PM7350

DSLAM WAN CARD REFERENCE DESIGN ERRATA

ISSUE 1: NOVEMBER 1999

This document is the errata notice for Issue 1 of the PM7350 DSLAM WAN Card Reference Design Board (document number PMC-990474).

Figure 1. Original jitter attenuation circuitry design. (Upstream data path for 1 out of 4 identical channels shown).

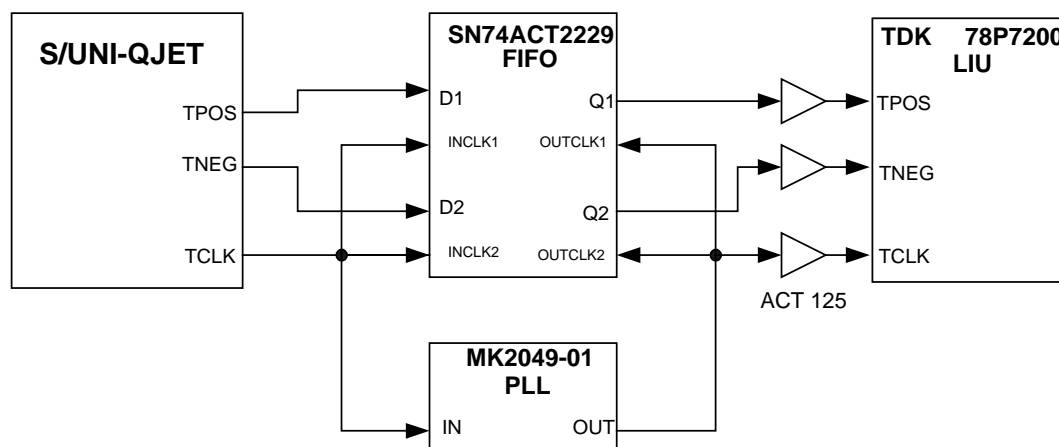
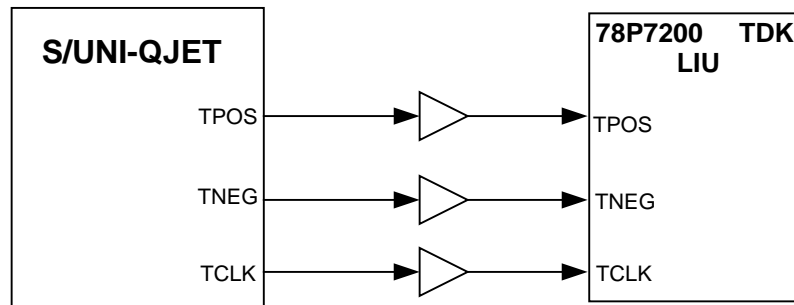
Problem: The DSLAM WAN Card had originally been designed with an added feature of meeting the specification for DS3 WAN jitter transfer. (Bellcore GR-499-CORE) This was to be accomplished using 4 FIFOs to synchronize upstream (destined for the WAN) data to a jitter-free clock, provided by 4 PLLs. (See figure 1). It has since been decided that this feature will be removed from the WAN Card due to complications in ensuring proper functionality of 4 PLLs in close proximity to each other.

Fix: The 4 PLLs used to de-jitter 44.736 MHz clocks & the 4 FIFOs should be removed from the design. The TPOS, TNEG, and TCLK signals from the S/UNI-QJET should be connected directly to the ACT125 buffers leading to the TDC LIUs. (See Figure 2). All code within the FPGA dealing with FIFO control should be removed.
